Hydrology and flooding impact assessment

Appendix E Record of Independent Peer Review of flood model

Peer Review of Flood Modelling undertaken for Narrabri to North Star - Phase 2

25 August 2022

Figure 3.1 Adopted 1 in 100yr AEP Inflow Hydrograph

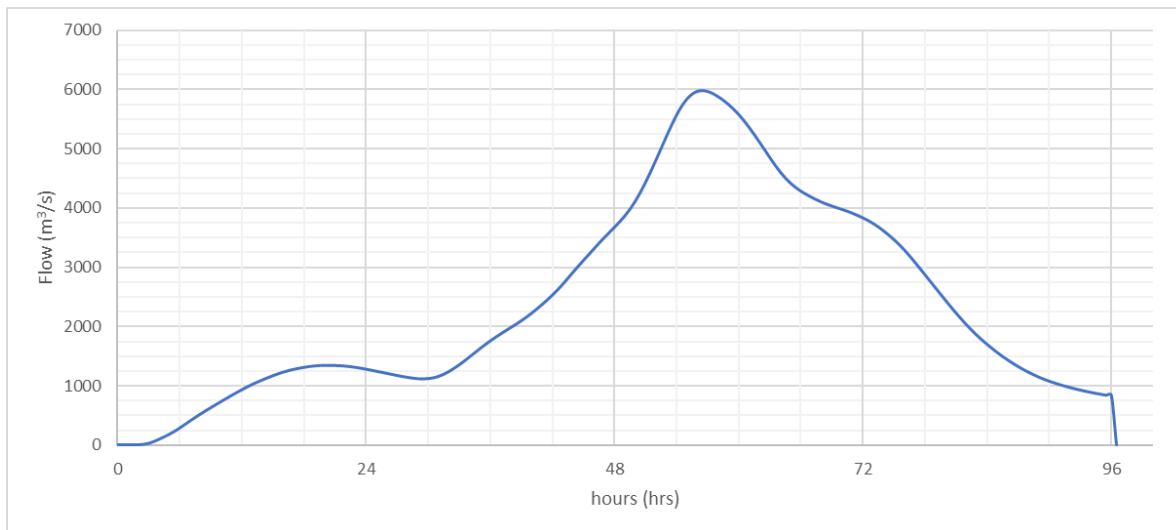
The above TUFLOW flood hydrograph is identical to the WRM (2017) Mike Flood hydrograph, including all other inflow boundaries.

Figure 4.3 March 2021 Calibration | NS2B & ARR (2019) Losses

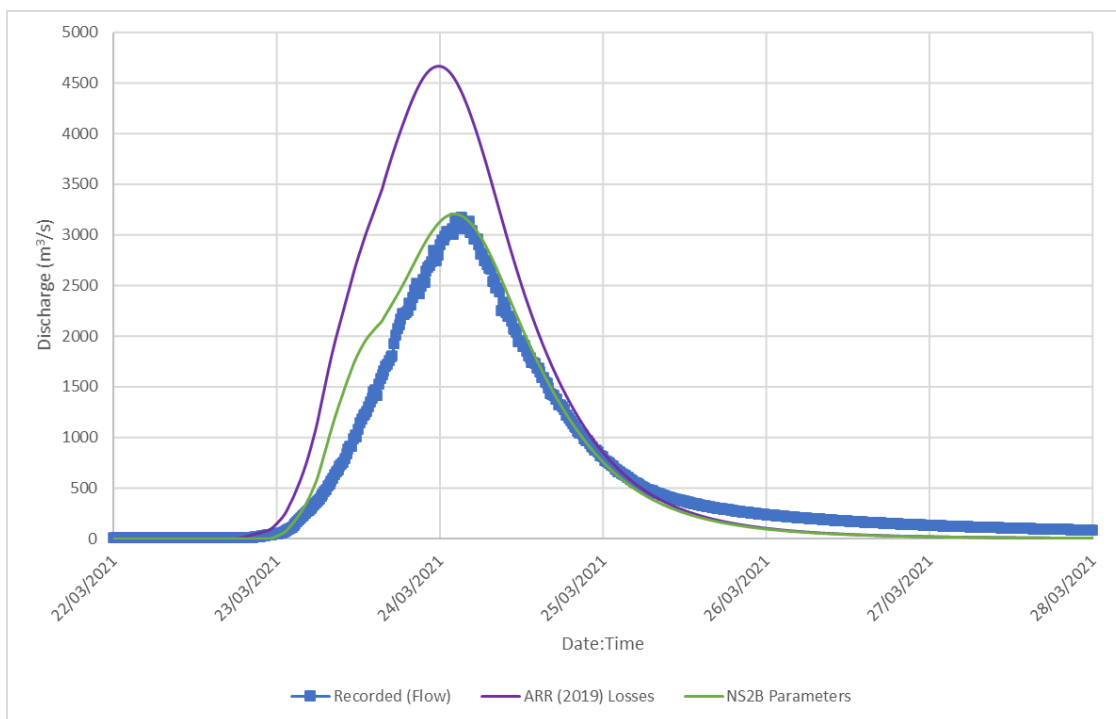
As presented in the above hydrograph above, the adopted NS2B parameters (i.e. Alpha, Beta, n, m, x and Reach length =1) provide a good calibration without any change to the standard parameters and losses that are consistent with the 'reconciled' losses. The ARR (2019) losses appear to substantially over estimate the peak flow flow by 50%.

Figure 4.4 1 in 100yr AEP Design Flows at Gravesend

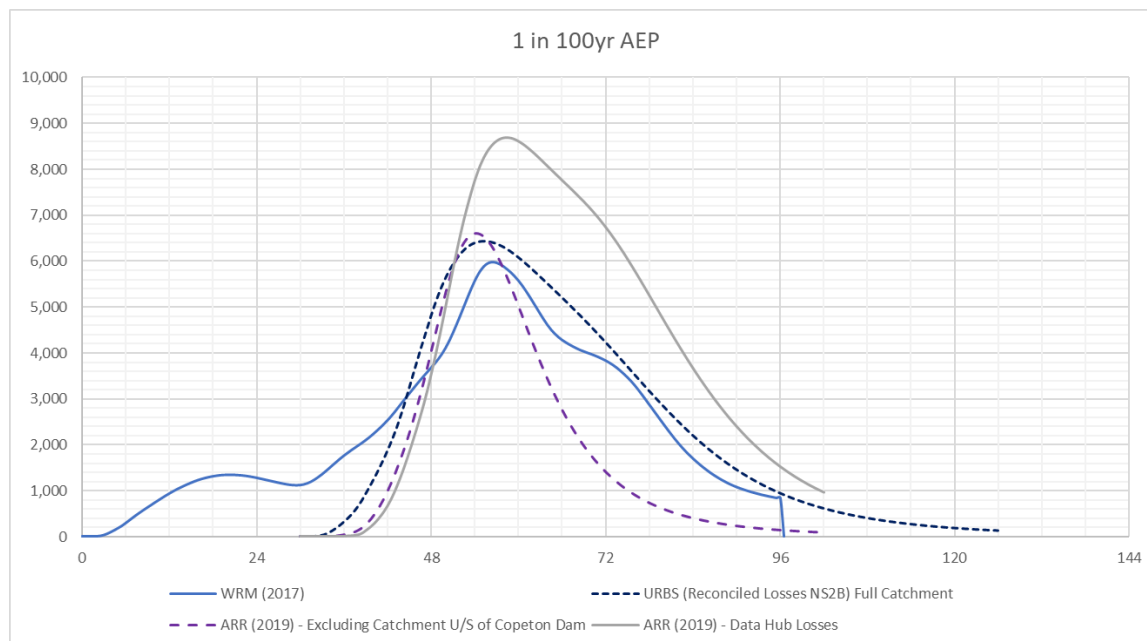
As noted in the above graph, the 'reconciled' design flows determined from the URBS catchment model compares well with the WRM (2017) adopted flow hydrograph, noting the URBS catchment model does not contain any attenuation effects from the Copeton Dam (i.e. URBS model is considered conservative since there is no attenuation from the dam), but includes the full catchment area. The ARR (2019) full catchment assessment with a peak flow in the order of 8,700m³/s appears to again over-estimate the peak flows determined by the FFA, but it does show the catchments sensitivity to continuing loss rates.

Figure 4.5 1 in 100yr AEP Adopted Design Hydrograph at Gravesend

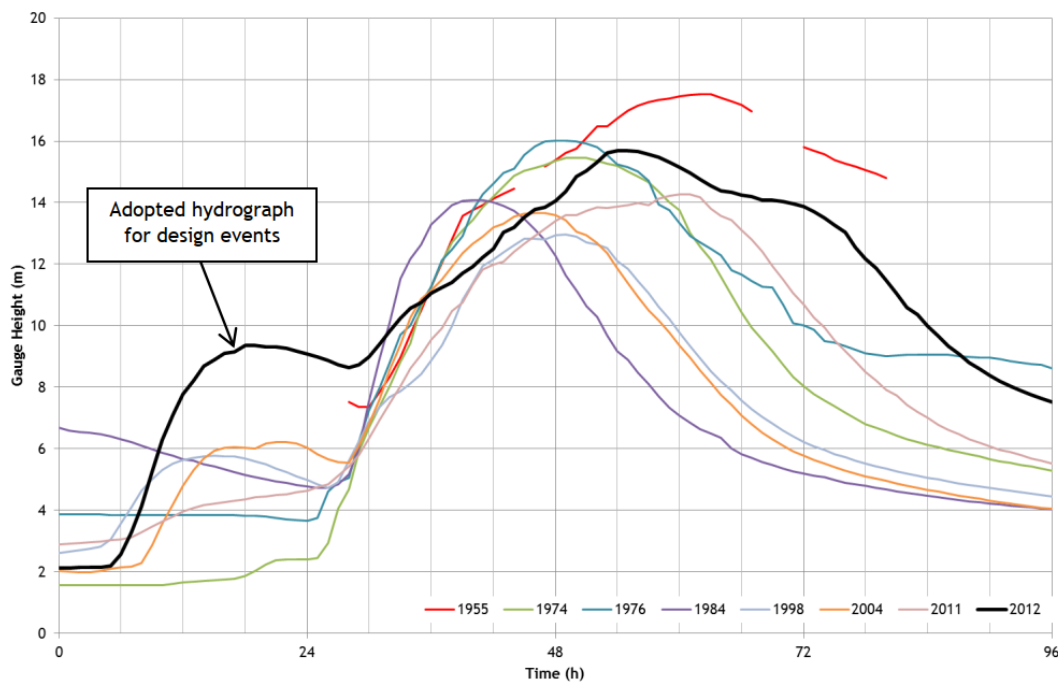
The above volumes indicate the WRM (2017) is likely to be conservative on volumes when compared with ARR (2019) standard ensemble flood events and hence the adopted flood hydrograph based on the use of the 2012 flood event is considered reasonable.

This is also demonstrated by the WRM (2017) historical flood water level hydrographs which are provided below for ease of reference.

Figure 5.2 Water Level Afflux

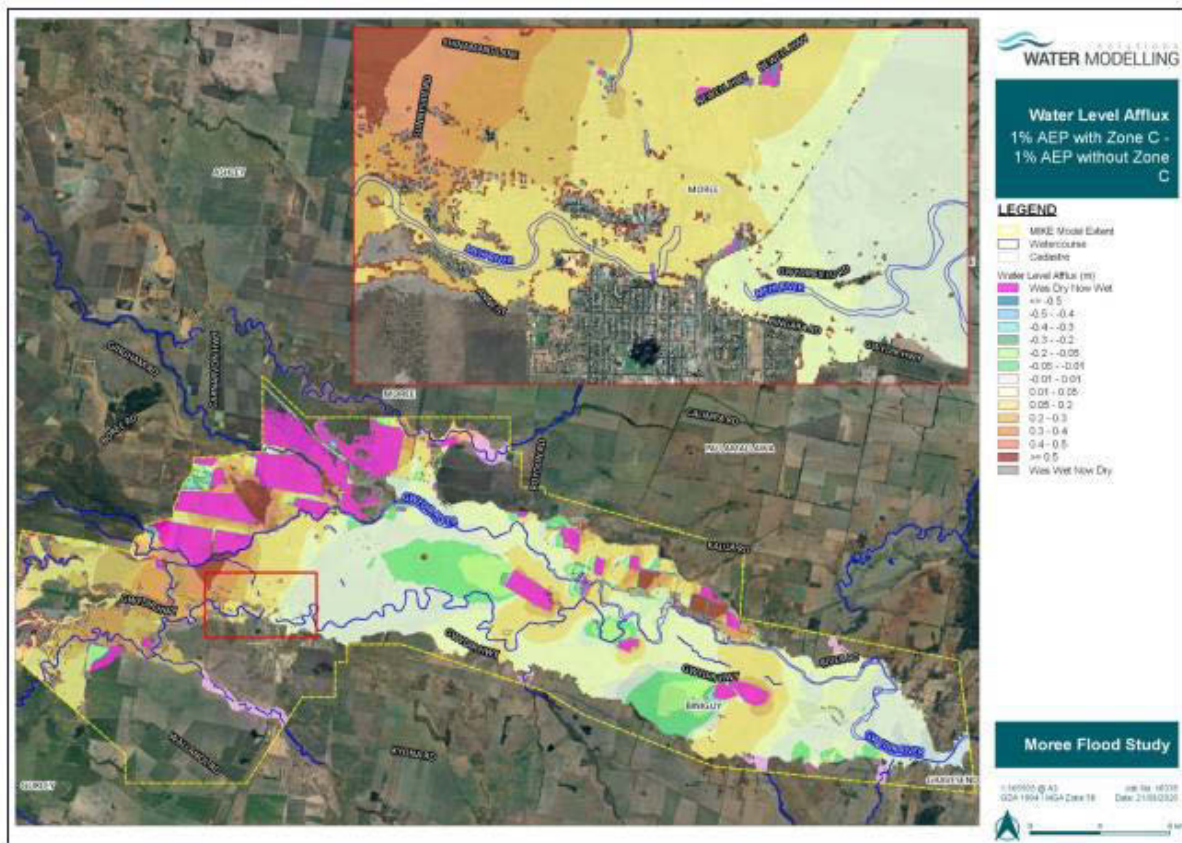
As part of these additional investigations by Moree, the nulled out levees were surveyed and included in the MIKE FLOOD model. The results indicate that the levees commence overtopping in the 5% AEP event and greater and for 1% AEP widespread overtopping of levees occurs. Afflux mapping indicates that up to 600mm reduction in flood levels across the floodplain and between 100-200mm in the northern section of Moree. Provided below in Figure 5.2, is an extract from the report showing the 1% AEP water level differences.

From our understanding, the revised levee modelling was recommended to be adopted by Council, and while the currently adopted TUFLOW modelling potentially provides a conservative analysis, a sensitivity assessment of the proposed design should be conducted at the detailed design phase with the current levee height included in the model.

1. Additional documentation and reporting in relation to the model verification;
2. Consideration of a historic event (e.g. Feb 2012) assessment for model validation.
3. A sensitivity test based on the revised MIKE FLOOD model incorporating existing levee/storage structures.
